from
**Southern
Water**

Your ref
BN/135/19/PL

Proposal: Subdivision of existing dwelling into two separate dwellings.

Site: BN/135/19/PL: - Birchwood House, Church Lane, Barnham, PO22 0DB.

Southern Water MapGuide Browser

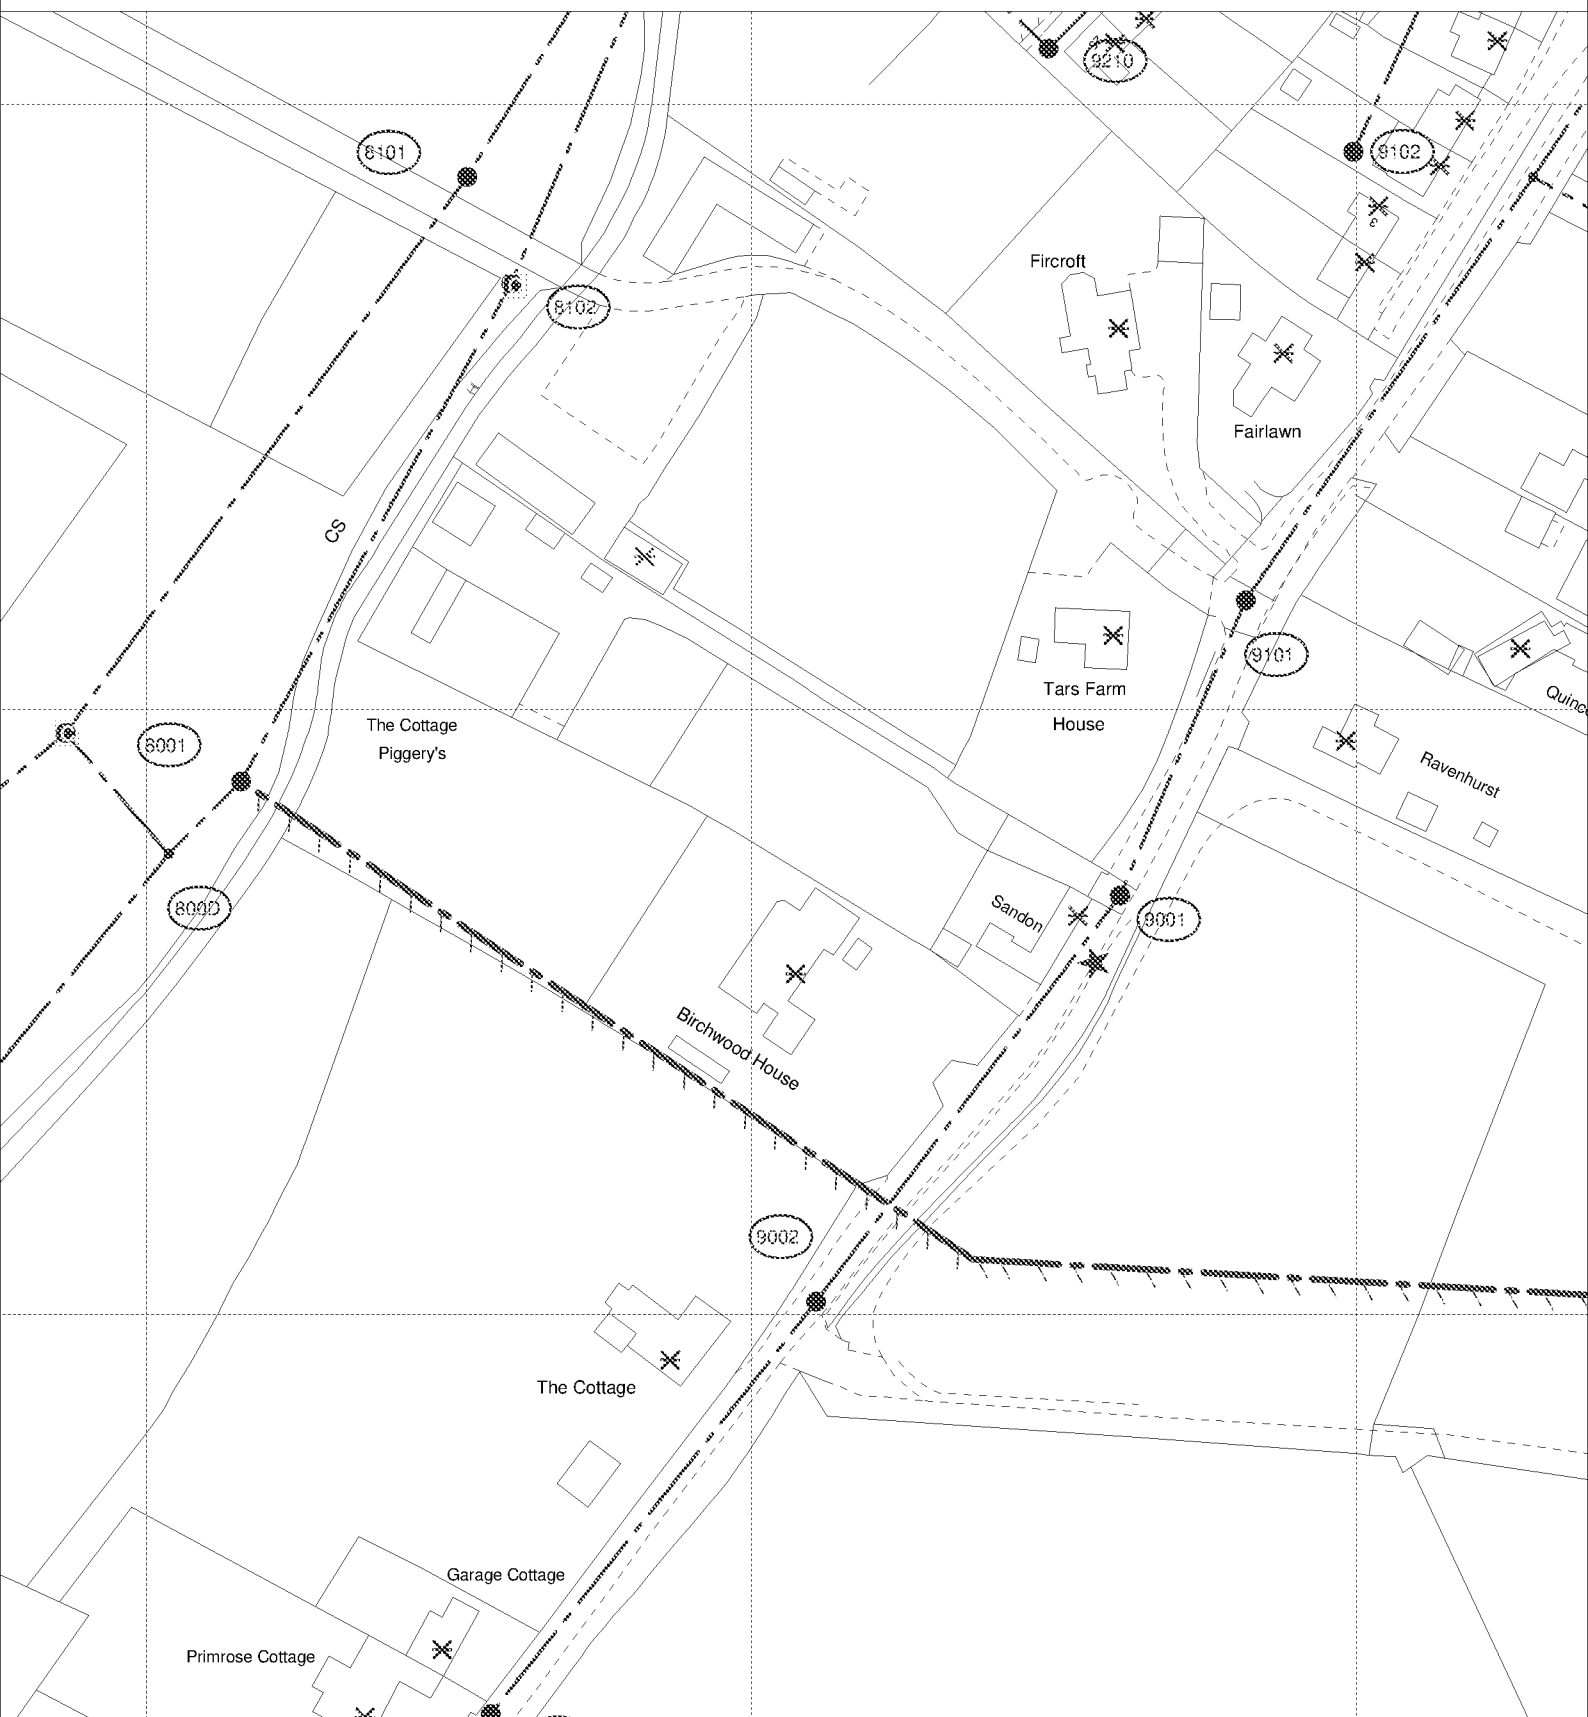
Please find attached a plan of the sewer records showing the approximate position of a public foul rising main crossing the site. The exact position of the public rising mains must be determined on site by the applicant before the layout of the proposed development is finalised.

- The 300mm foul rising main requires a clearance of 3 metres on either side of the public rising main to protect it from construction works and to allow for future access for maintenance.
- No development or tree planting should be carried out within 3 metres of the external edge of the public foul rising main without consent from Southern Water.
- No soakaways, swales, ponds, watercourses or any other surface water retaining or conveying features should be located within 5 metres of a public foul rising main.
- All existing infrastructure should be protected during the course of construction works.
